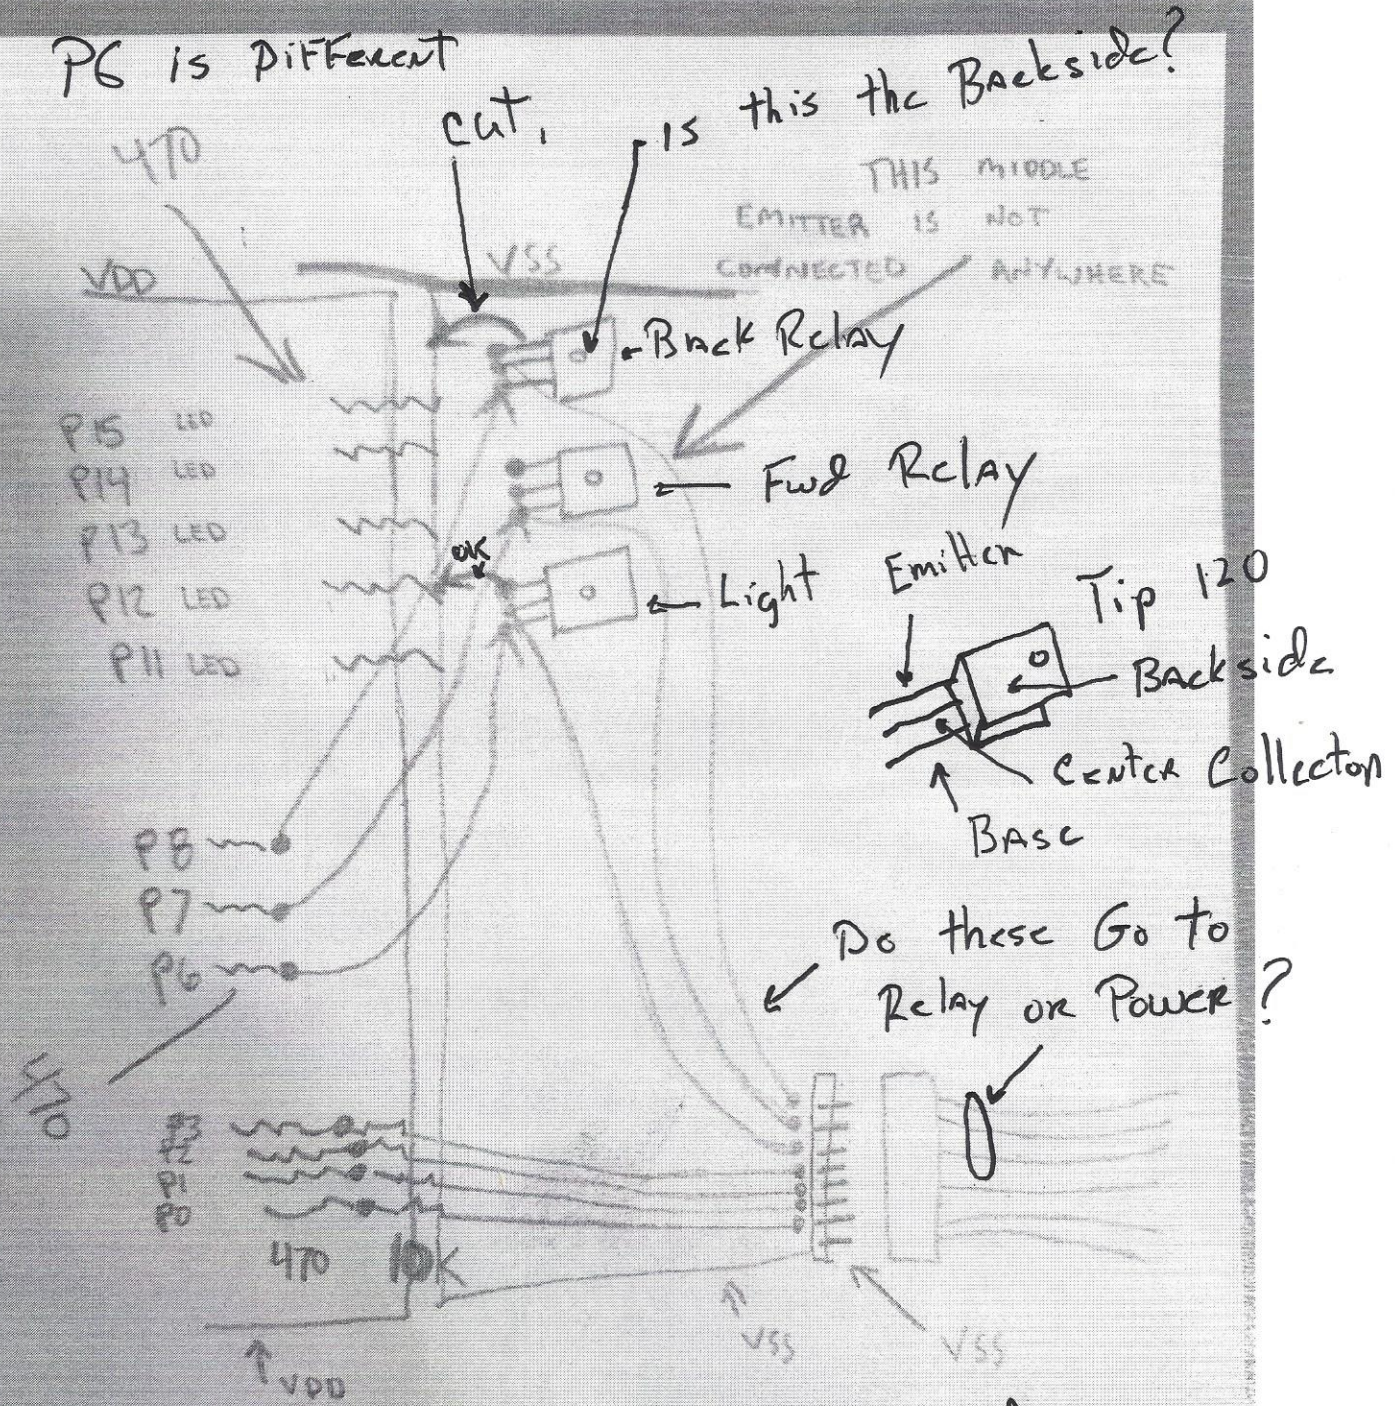
The Red Dots Are Emitters they connect to Relay coil on P7 and P8

P6 is different

IF the Blue Lines are connected to the center pin, that is collector. Find out were those Blue Lines connect too, Relay or Power?
